## Bulletin

**Application: Jatco JR403E**

**Subject: Pump Gasket Update**

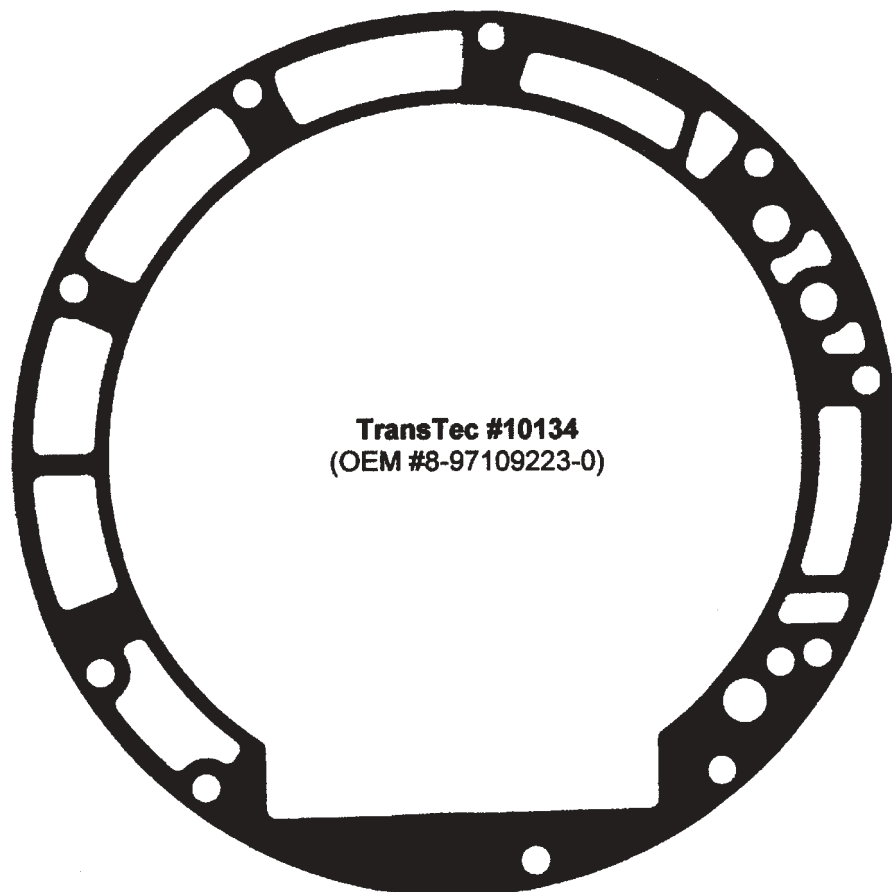
The pump gasket for the Jatco JR403E has been changed from a paper material to a latex-coated, metal gasket. The new gasket offers superior protection against blowout.

In keeping with our OE quality commitment, we will also be offering this gasket in our Overhaul Kits. The TransTec part number for the gasket is #10134 (OEM #8-97109223-0).

All TransTec kits with a date code of K01 and later contain the new gasket.
